**PRYOR PUBLIC SCHOOLS
PRYOR JR HIGH SHELTER
ADDITION**

a
d
d
e
n
d
u
m

n
o
.
t
h
r
e
e

addendum number: THREE (3)
date: 10.21.2019
project: PRYOR PUBLIC SCHOOLS
Junior High Shelter Addition
PRYOR, OK
project number: 1803
architect: The Stacy Group
8091 N. Owasso Expressway
Owasso, OK 74055
(918) 272-2622
f (918) 272-2633

LIGHTING
PLAN

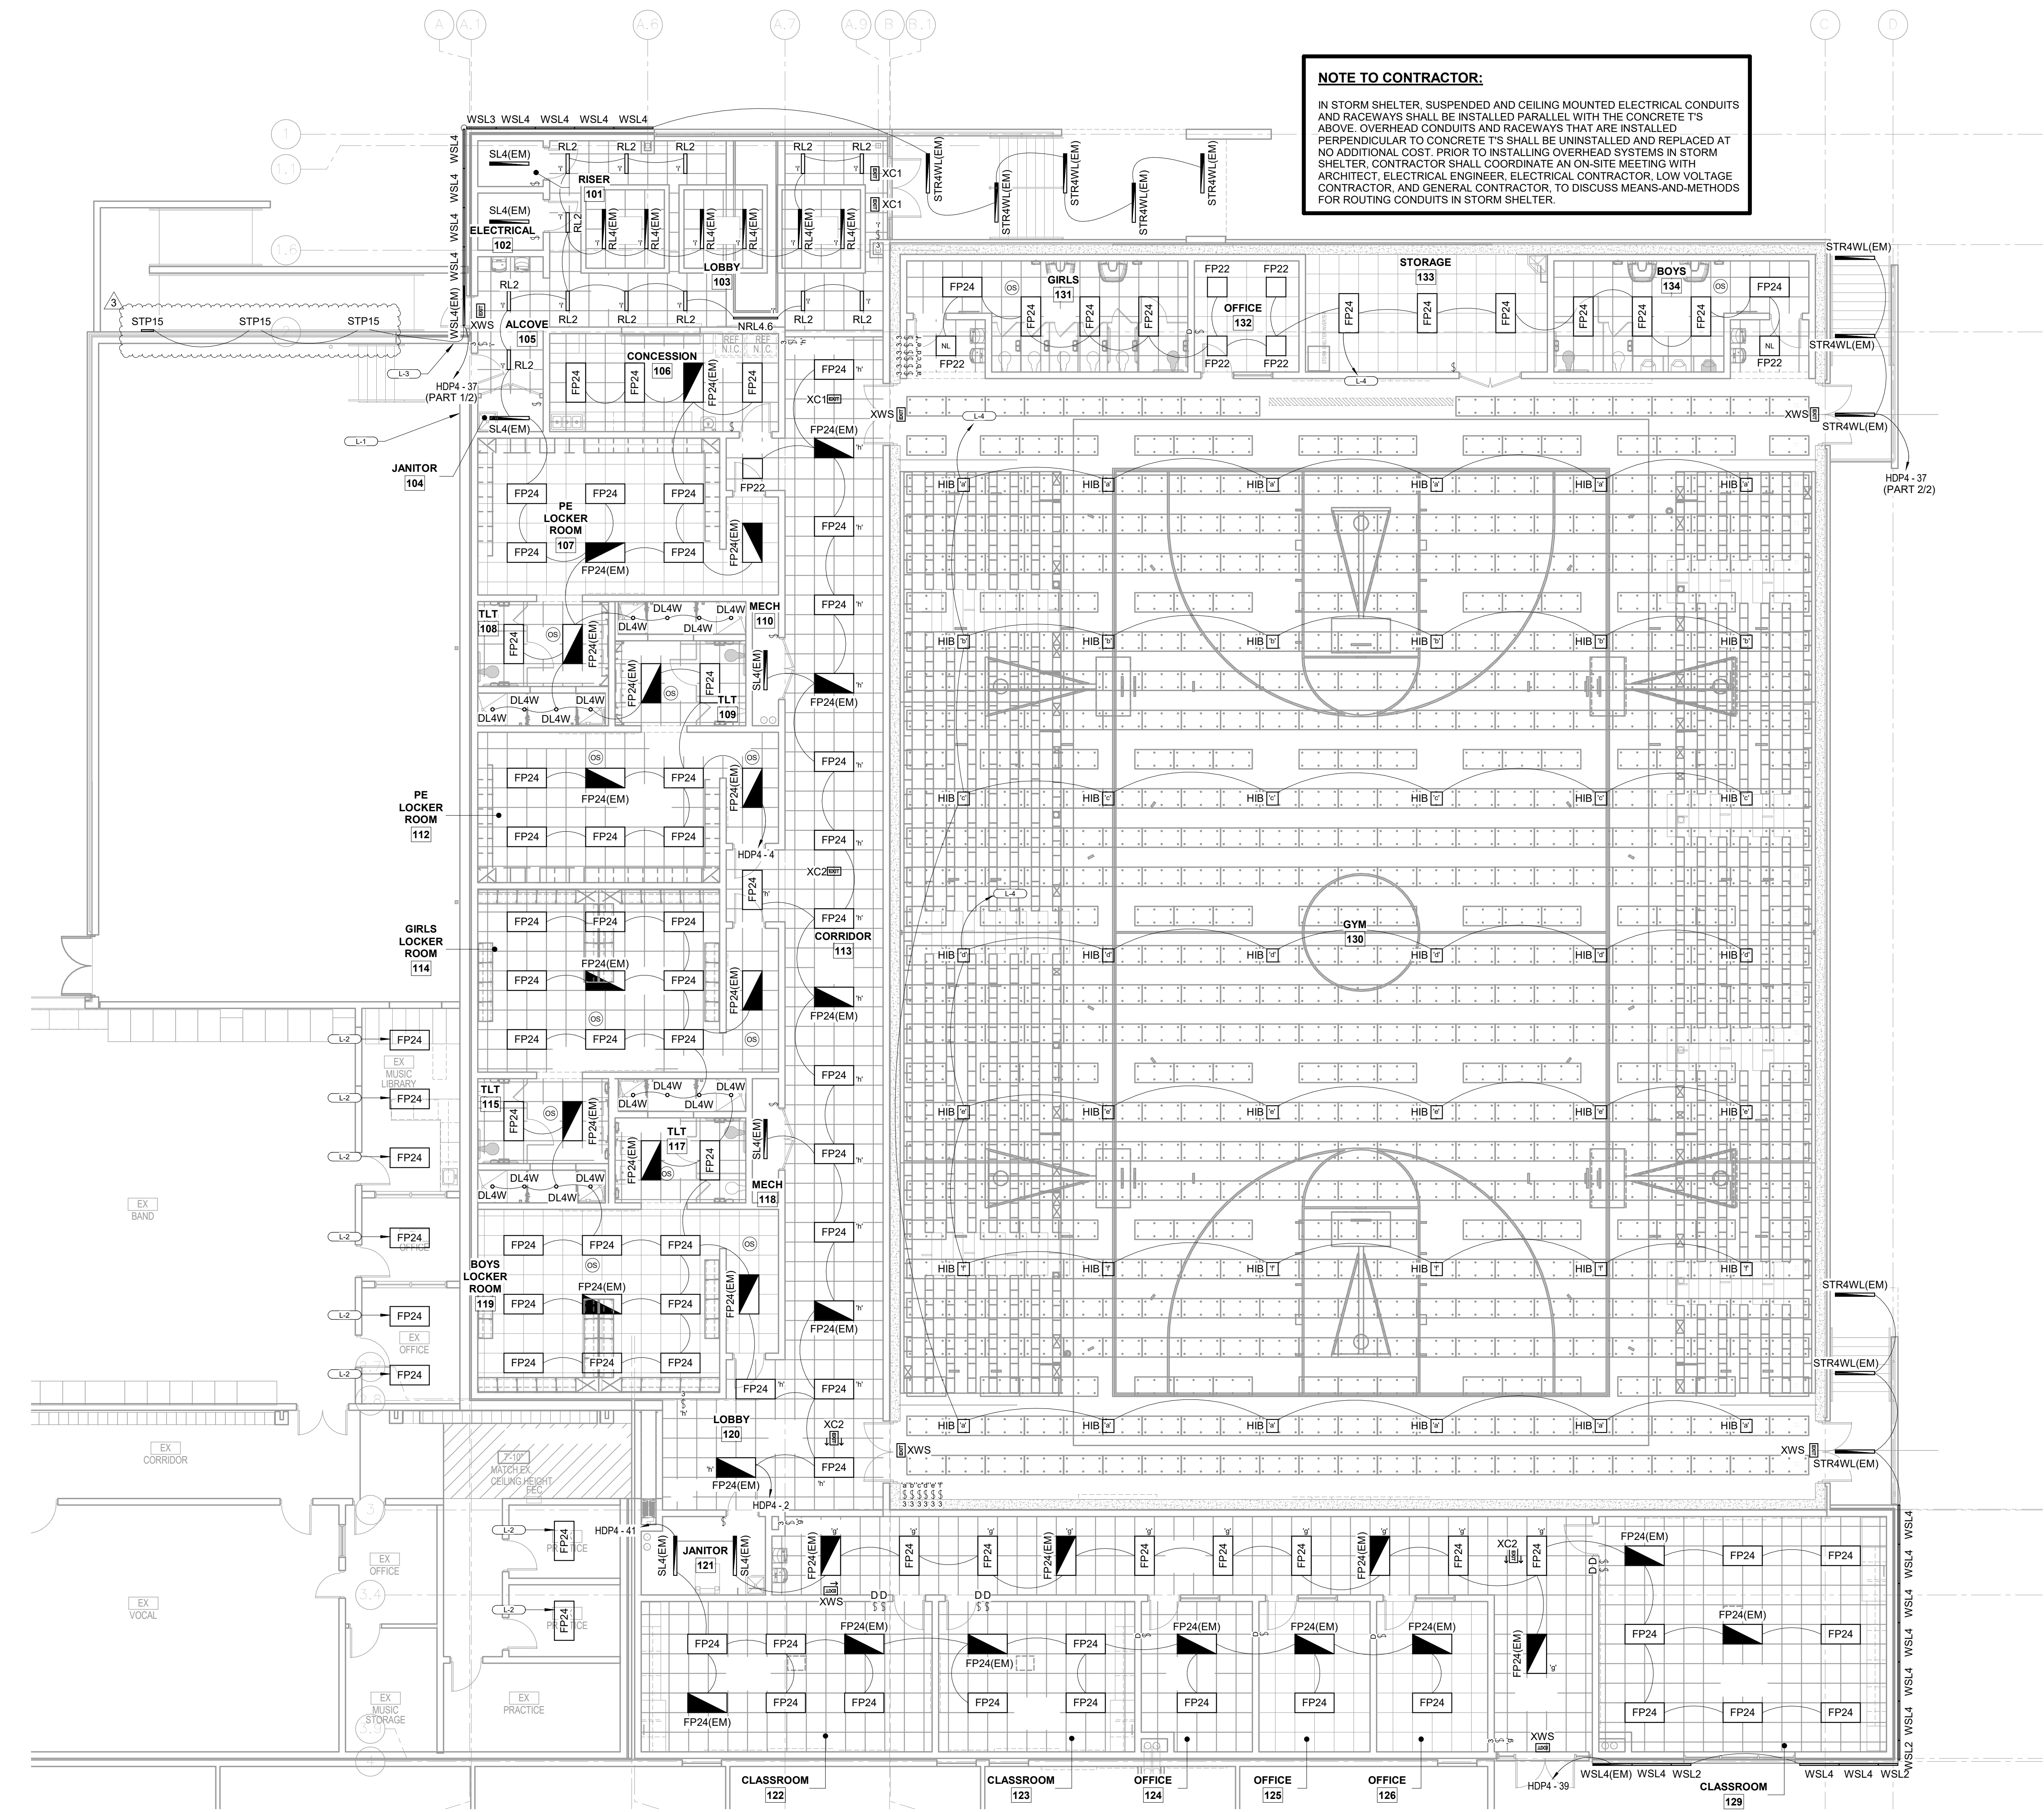
A3-4 Sheet E201 Lighting Plan: Clarify circuiting requirements for (3) exterior step lights.

**LOW VOLTAGE
DETAILS**

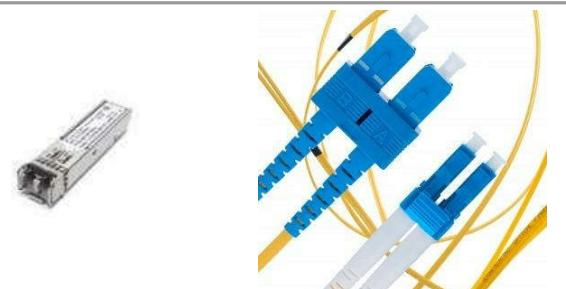
A3-5 Sheet E701 Low Voltage Details: Add sheet to drawing package to clarify Div. 27 and Div. 28 scopes of work.
